[Crandon Mine Project comments]. Volume 4 1984-1986

COMMENTS ON PRICKETT'S MINE INFLOW MODEL
AS DOCUMENTED IN "GROUND WATER INFLOW MODEL
FOR THE PROPOSED CRANDON MINE"

Responses to DNR comments on the Revised EIR, DNR Letter Dated December 28, 1984

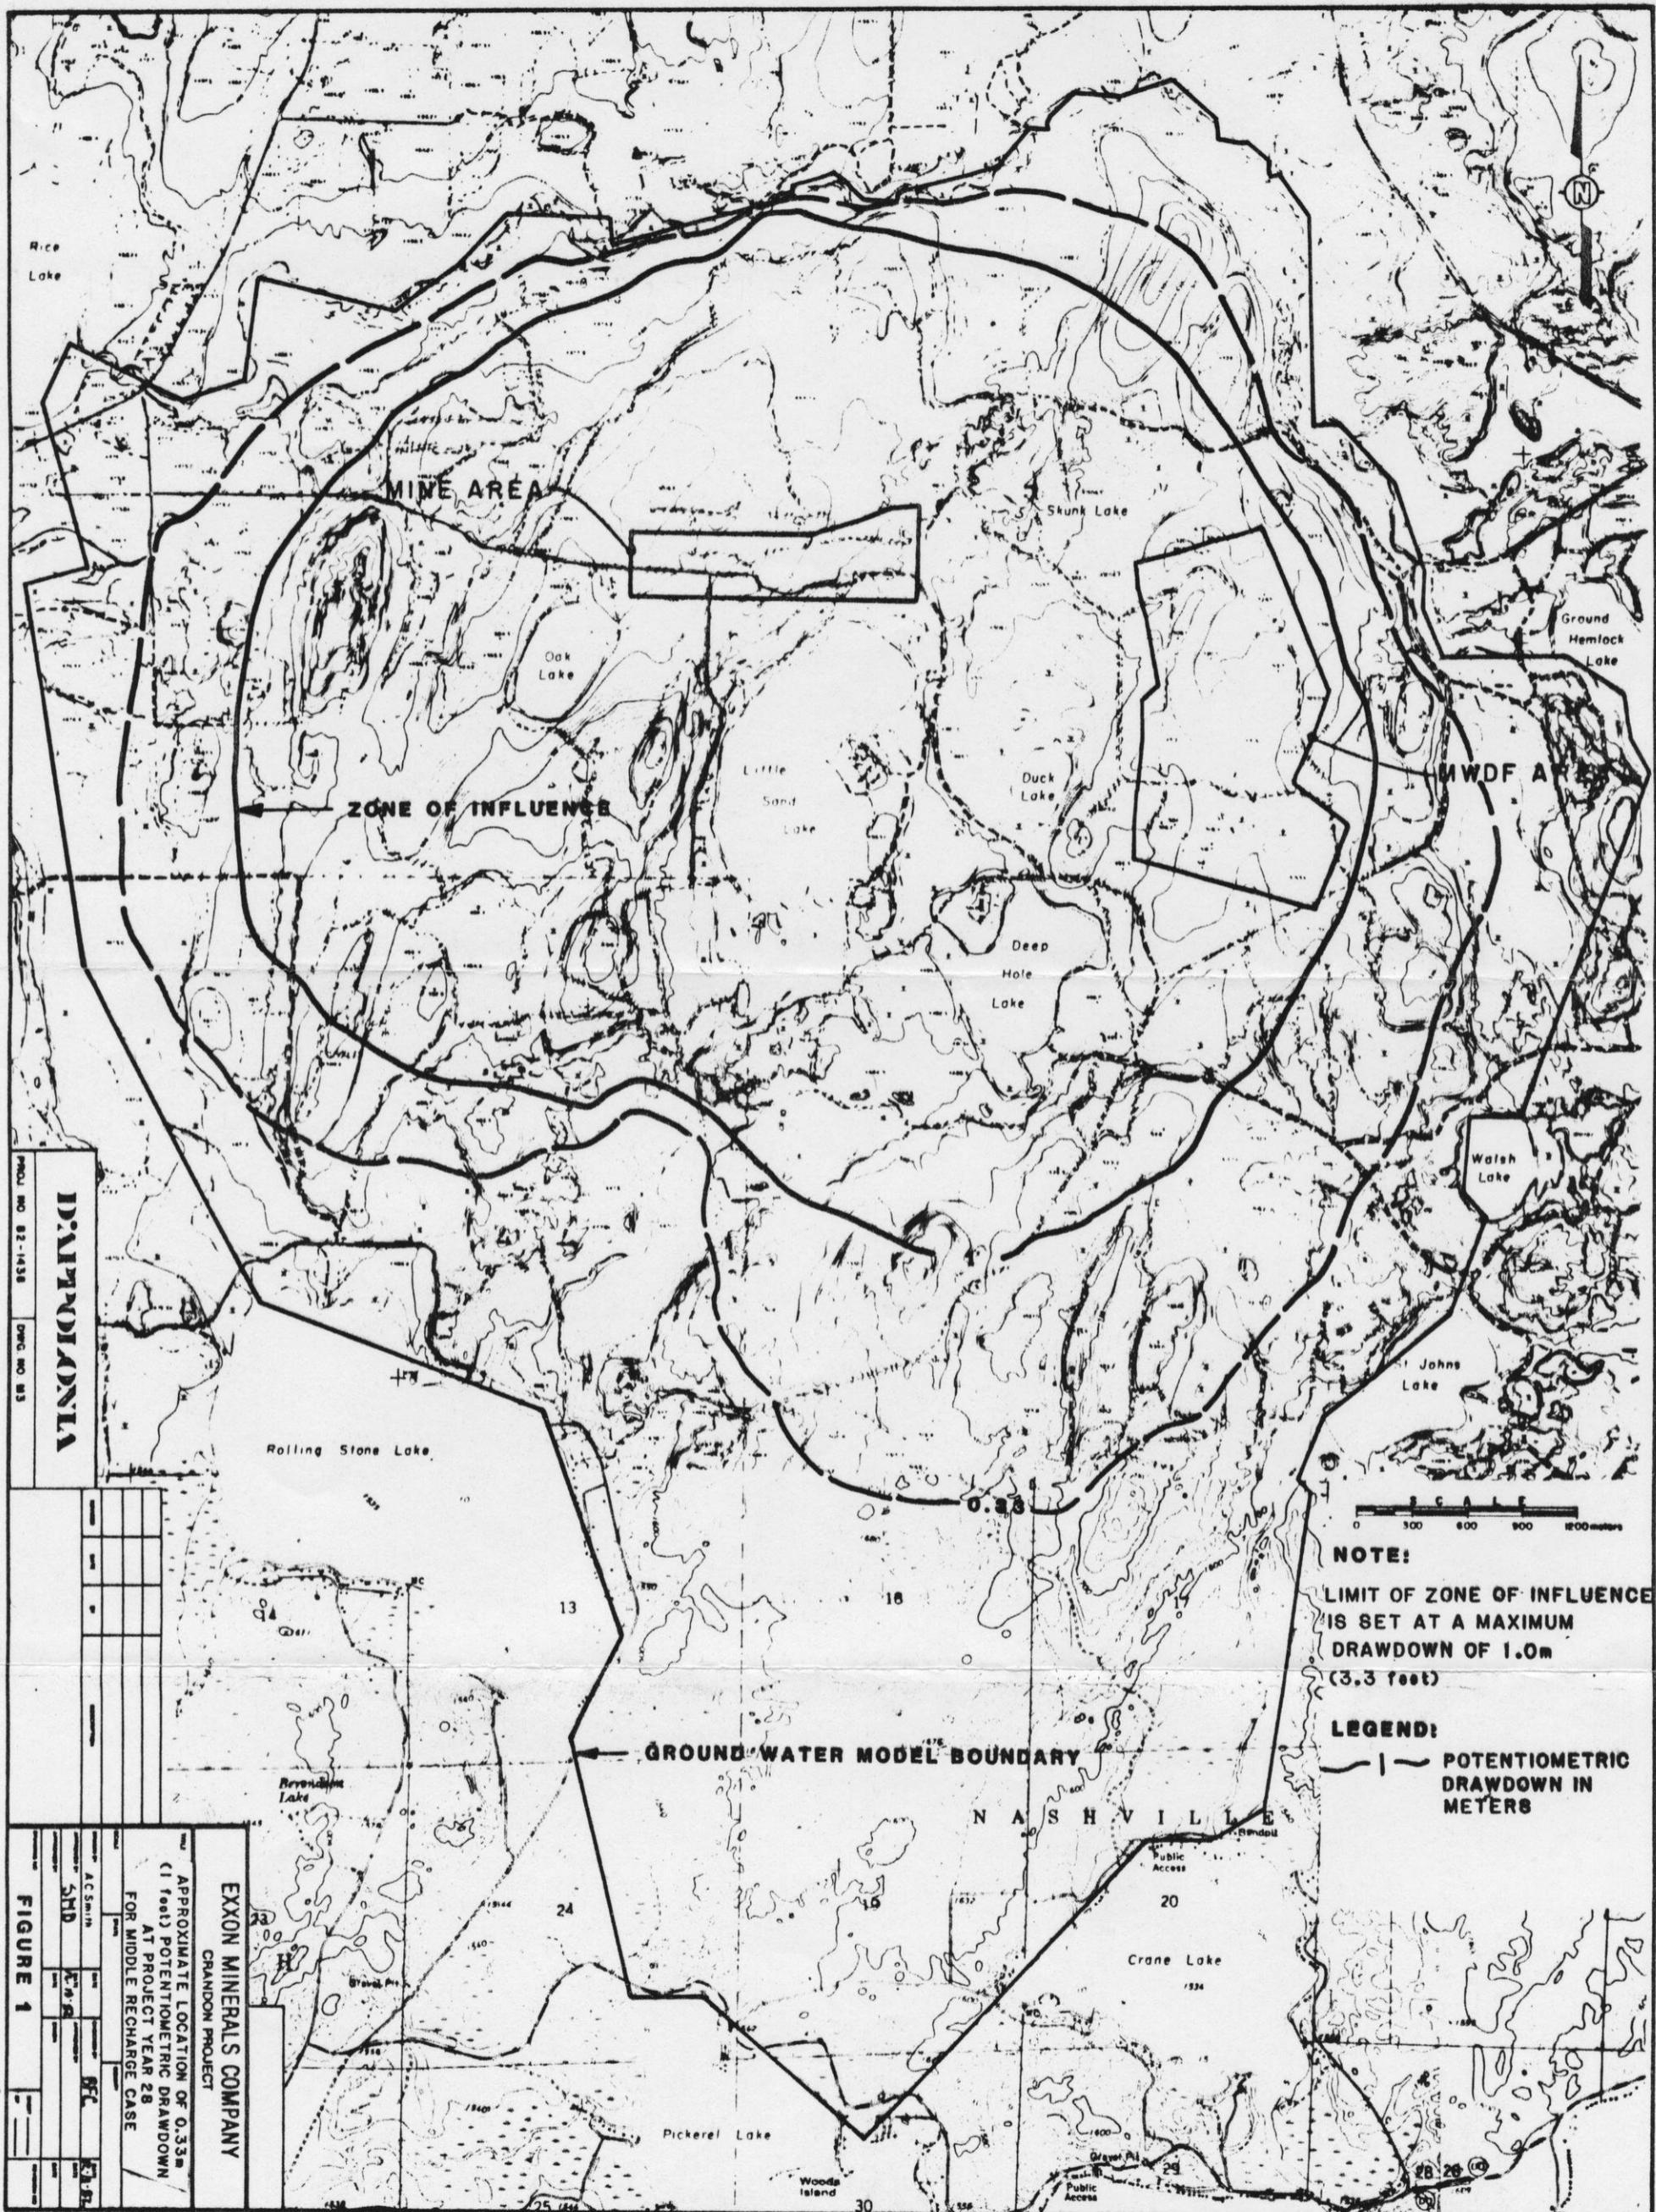
Attached Figure 1 depicts the locations of the 1 m (3.3 foot) and 0.33 m (1.0 foot) drawdown contours at Project year 28 for the expected mine inflow value for the middle recharge case (8.5 inches). Project year 28 has been used in EIR Appendix 4.1.A to portray steady-state conditions for mine inflow and ground water drawdown effects. Other study work associated with the preparation of Appendix 4.1.A determined that the drawdown changes were approximately the same for all three (low, middle, and high) recharge cases.

FIGURE 1.1-5

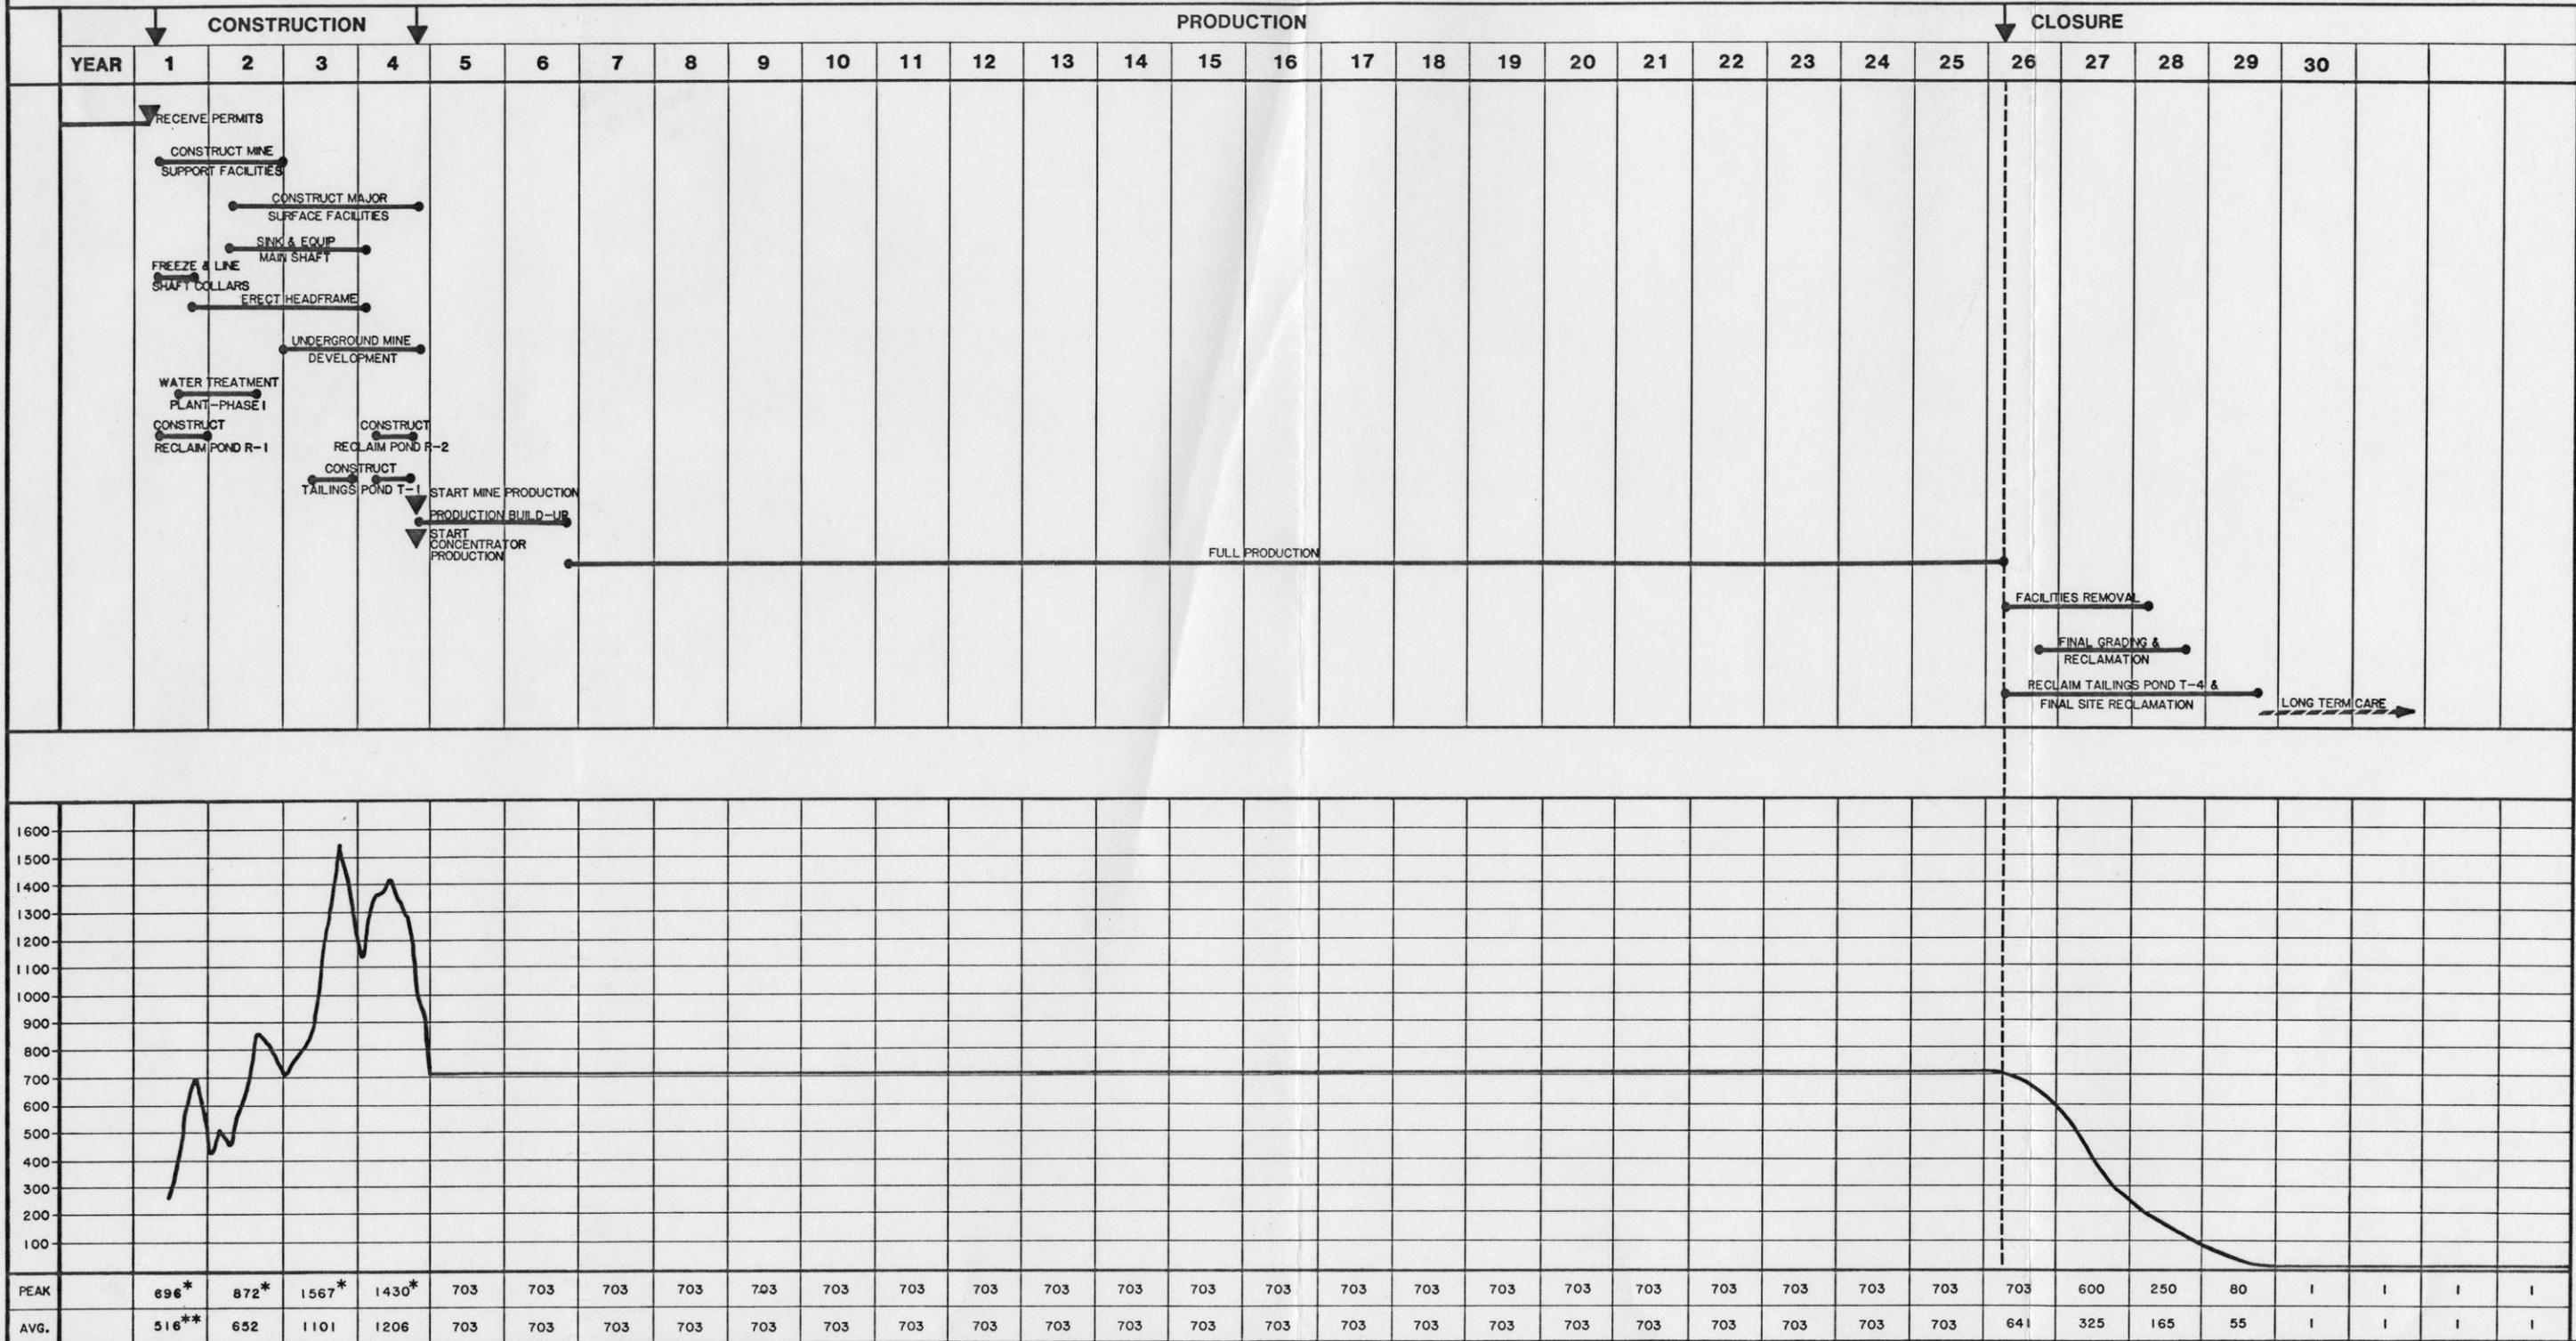
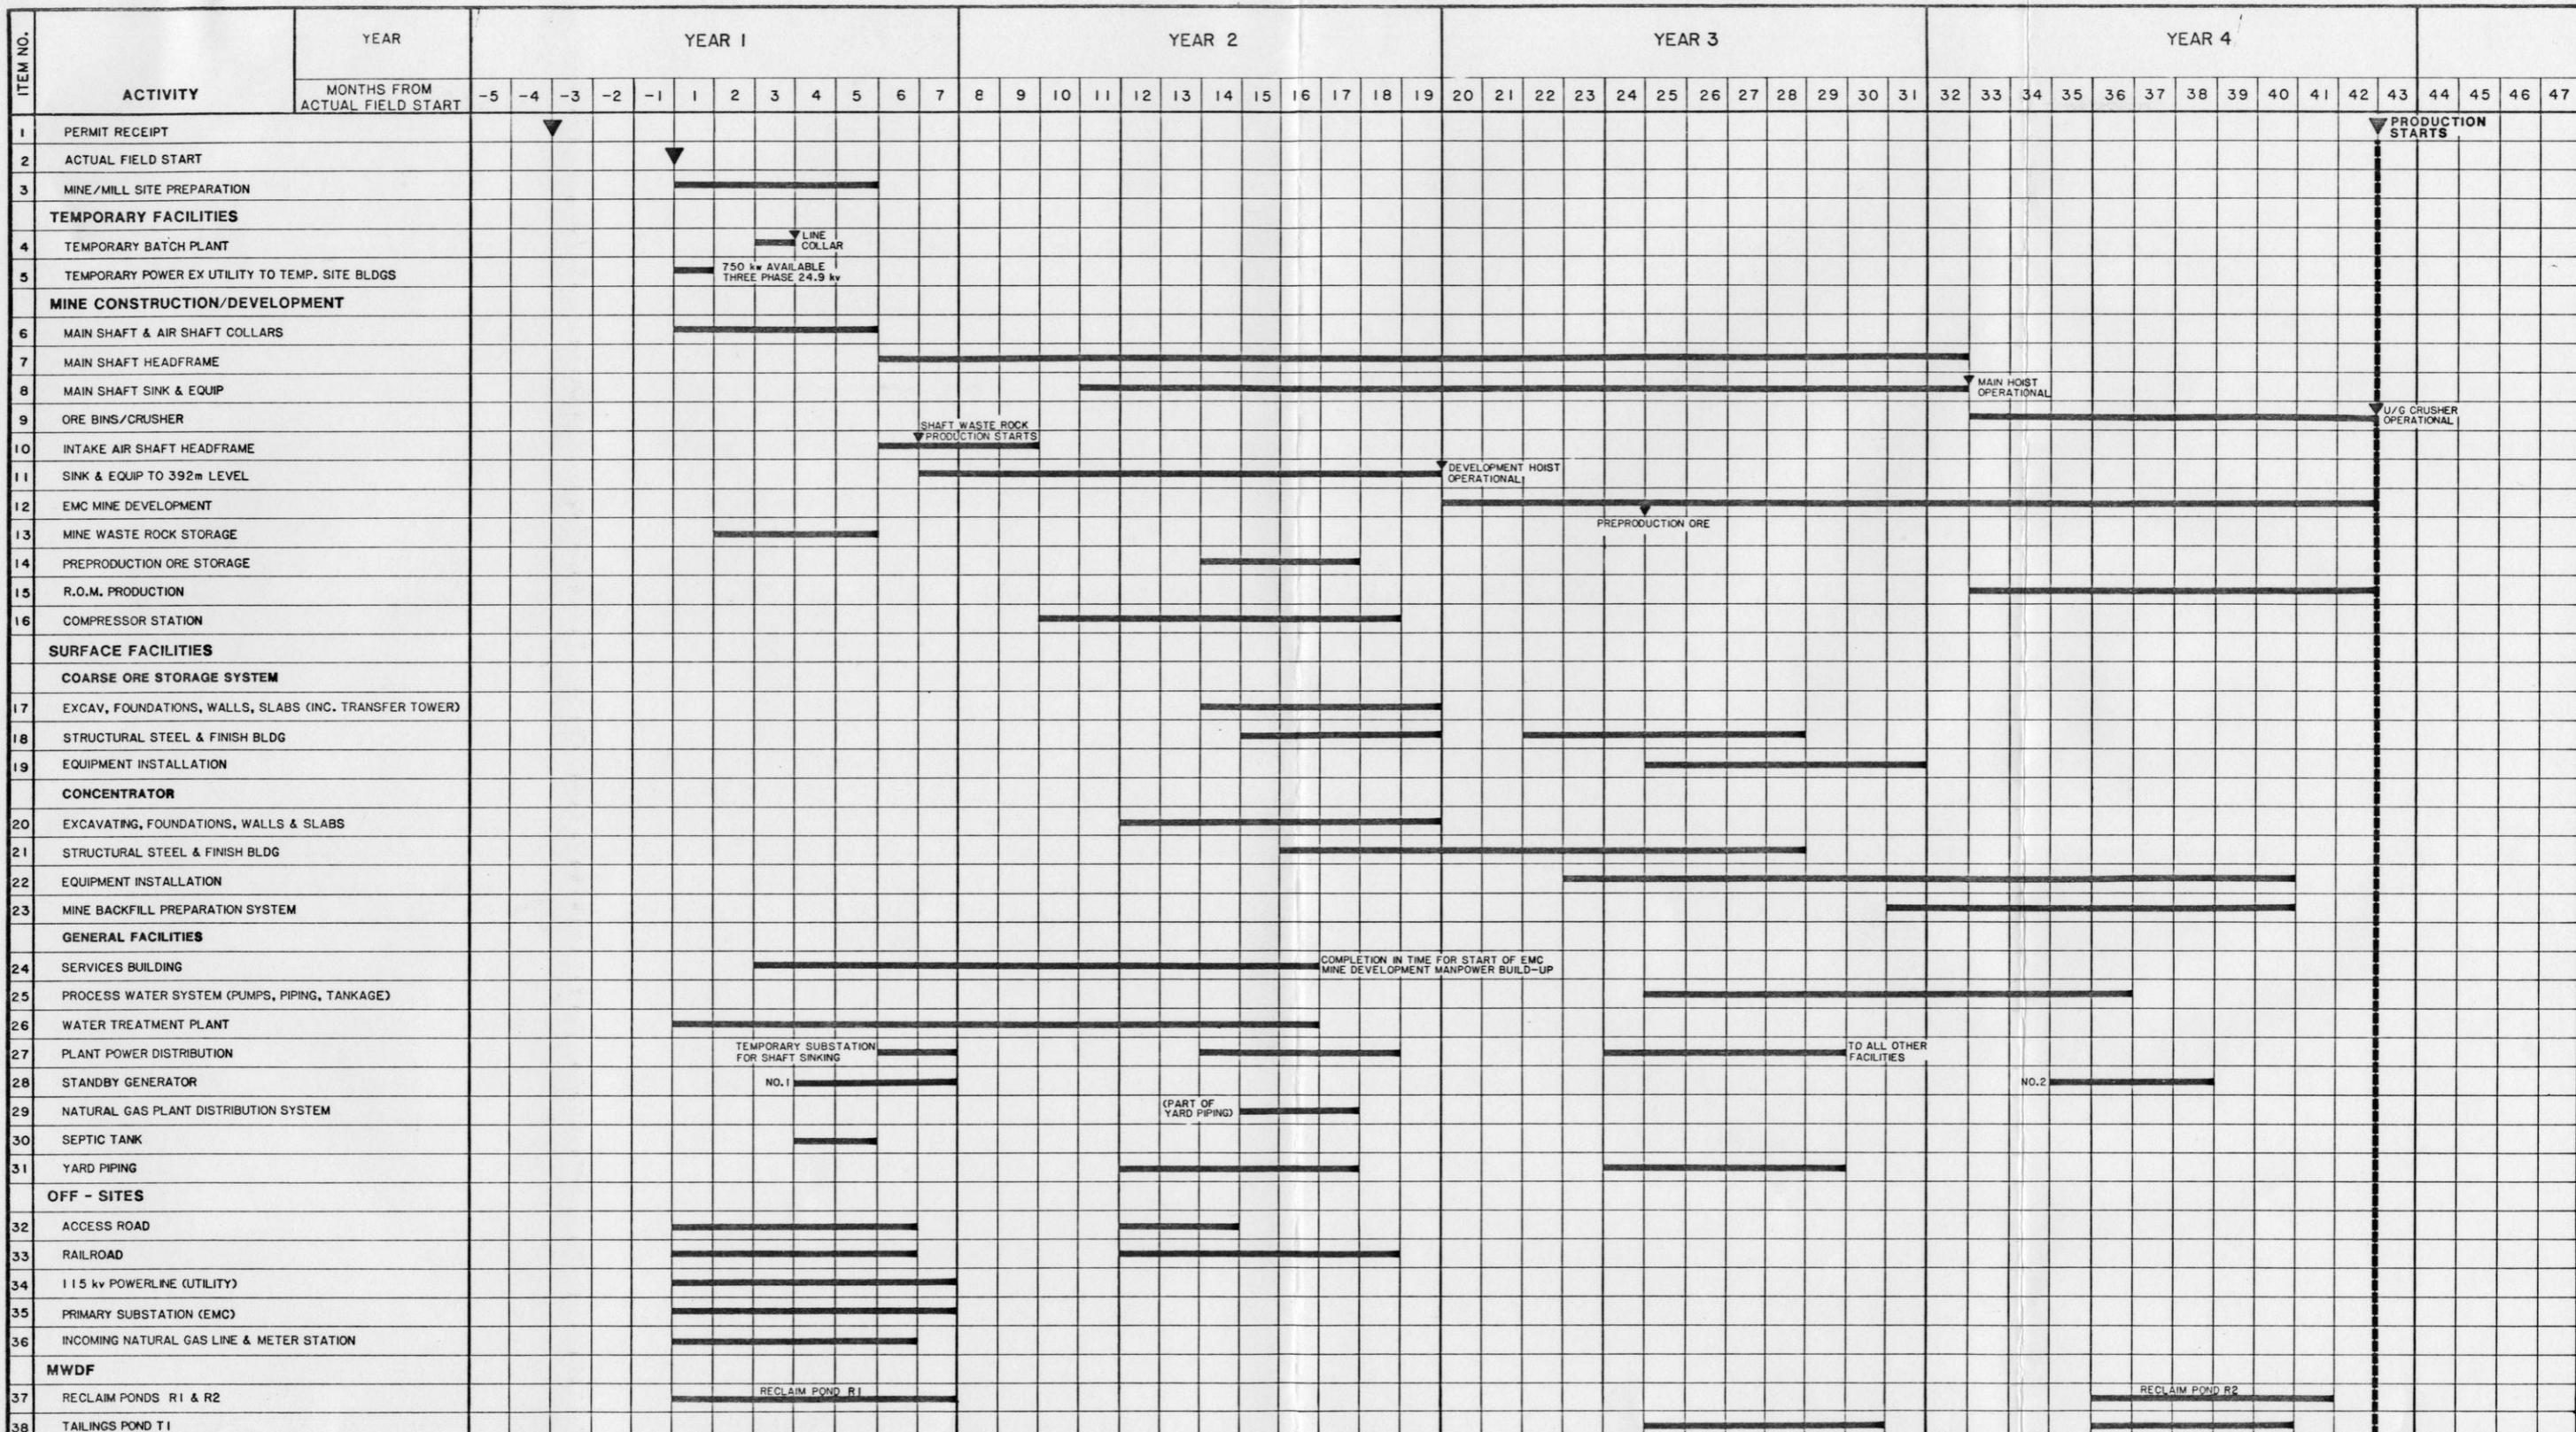
Figures 1.1-15 and 1.3-19 show the construction schedule for the entire project, including that for the wastewater treatment plant (WTP) and the reclaim ponds. These schedules differ significantly from that presented for the WTP in the Preliminary Engineering Report dated October 19, 1984. Which is the correct schedule? Is there an updated EIR project schedule available?

It is presumed that the above referenced figure is 1.1-5 as there is no Figure 1.1-15.

Figures 1.1-5 and 1.3-19 from the revised EIR showing the Project construction schedules have been updated and are consistent with the wastewater treatment plant (WTP) Preliminary Engineering Report dated October 19, 1984. The updated Project schedules were contained in the February 1985 revision to Chapter 1 of the EIR which was previously submitted to the DNR. Copies of these figures are attached.
